Master Plan Amendment #2018-0006
Text Amendment #2018-0012
Rezoning #2018-0005
CDD Concept Plan #2018-0005
Development Special Use Permit #2018-0006
TMP Special Use Permit #2018-0077
Public Storage / BoatUS –
880 & 890 South Pickett Street and 620 Burnside Place

Application	General Data	
Project Name: Public Storage/BoatUS	PC Hearing	March 5, 2019
	CC Hearing	March 16, 2019
	If approved, DSUP Expiration	March 16, 2022 (three years)
	If approved, CDD Expiration	March 16, 2034 (15 years)
	Plan Acreage	7.3 acres (317,957 SF)
Location: 880 South Pickett Street, 890 South Pickett Street and 620 Burnside Place	Existing Zone	I / Industrial
	Proposed Zone	CDD #26 / Coordinated Development District #26
	Proposed Uses – CDD Phase I and DSUP	Storage/Warehouse (self-storage), Vehicle Storage (interim), and Open Space
	Proposed Uses - CDD Phase II	Storage/Warehouse (self-storage), Multifamily Residential, and Open space
	Net Floor Area – CDD Phase I and DSUP only:	259,120 SF
	Net Floor Area – CDD Phase II only	473,492 SF
Applicant: PS Southeast One, Inc. by Mark Viani, attorney	Small Area Plan:	Eisenhower West
	Historic District:	Not applicable
	Green Building:	LEED Silver or equivalent for no

Attachment #2: Master Plan Amendment Revised Map Page 27

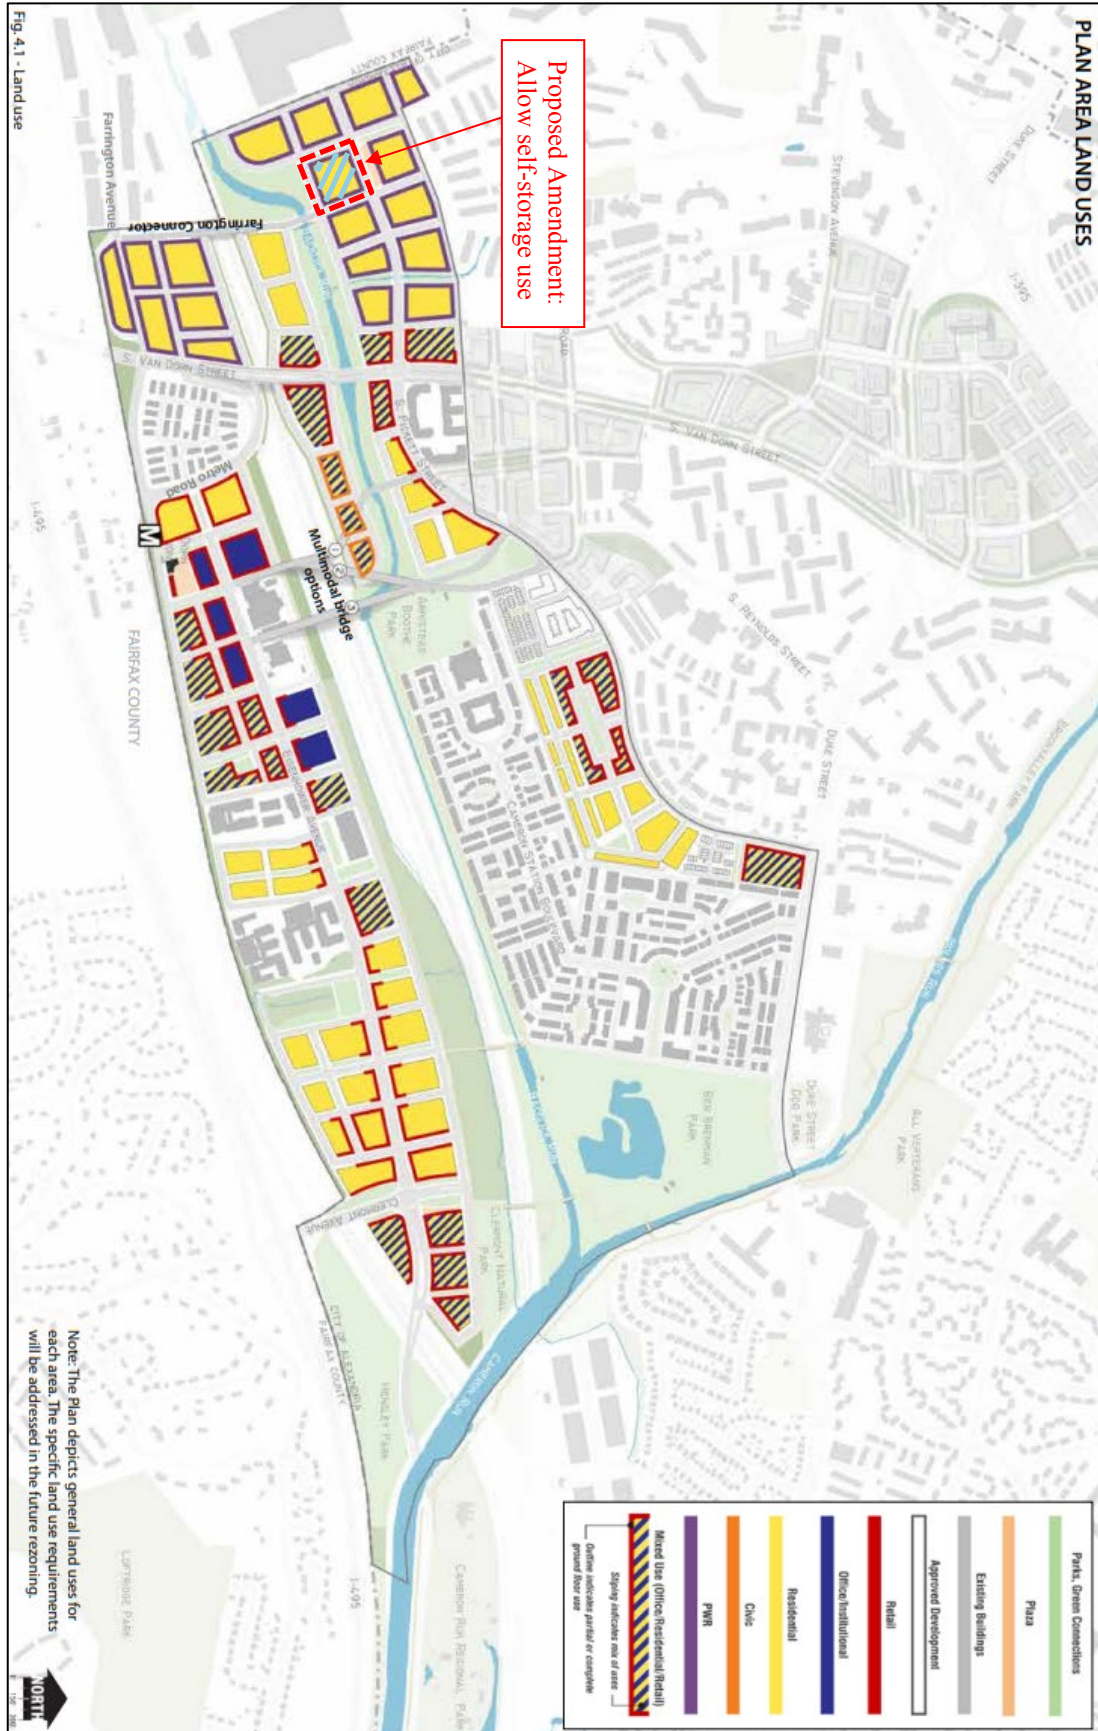
The Plan designates this site as a location for residential with retail and production, wholesale and repair (PWR) uses. Staff recommends amending the land use map to include self-storage use on the site. Staff is not opposed to this amendment because of the various other Plan elements achieved, as stated previously. However, staff recommends that the definition of Production, Warehouse, Repair within the Plan be amended to exclude storage/warehouse for future sites.

Revise the definition of PWR uses on Page 32 to specifically exclude storage/warehouse uses.

Figure 3: Staff proposed elevation - north

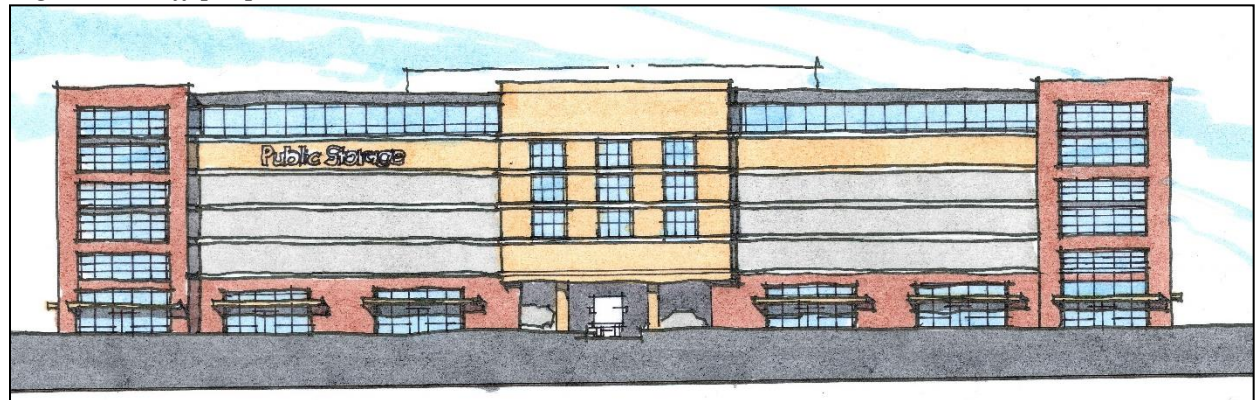
The team proposed the elevation changes, as shown in Figure 2 (attached). While the revised design is consistent with the above requests, staff recommends additional refinements to the building skin, as shown in Figures 3 and 4, and detailed in the Discussion section below.

While staff is supportive of the general design direction proposed in Figure 2, additional refinements are suggested:

18. **CONDITION AMENDED BY PLANNING COMMISSION:** Provide the following building refinements to the satisfaction of the Director of P&Z:
- a. Revise the ground-level building façade to incorporate the additional commercial uses requested in Condition #15 as part of the final site plan submission and as generally shown in Figures 3 and 4;

- i. The projecting accent elements near the center of all four facades shall be consistently detailed using horizontal metal siding and incorporate upper-level glazed openings, as generally shown in Figures 3 and 4. Colors shall be determined during the final site plan review;
